PCN-20190829 TEI0009-02 Under Voltage Protection Change

Company	Trenz Electronic GmbH
PCN Number	PCN-20190830
Title	TEI0009-02 Under Voltage Protection Change
Subject	Trenz Electronic TEB0724 Hardware Change
Issue Date	2019-09-05

affected product
TEI0009-02

#1 Replaced R27 by 953kOhm and R32 by 147kOhm

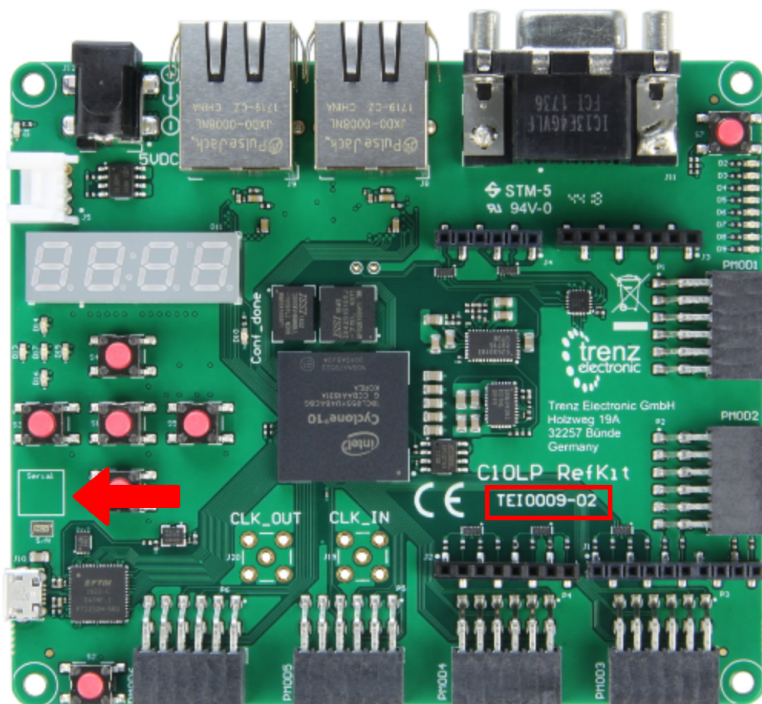
Reason: Large start up currents led due to adverse conditions (e.g. weak powersupply, long wires, increased contact resistance) to a voltage drop below the under voltage lock out limit of the input protection circuit.

Impact: Under voltage protection limit is decreased to 4.06V, which gives a larger margin for a voltage drop during start up.
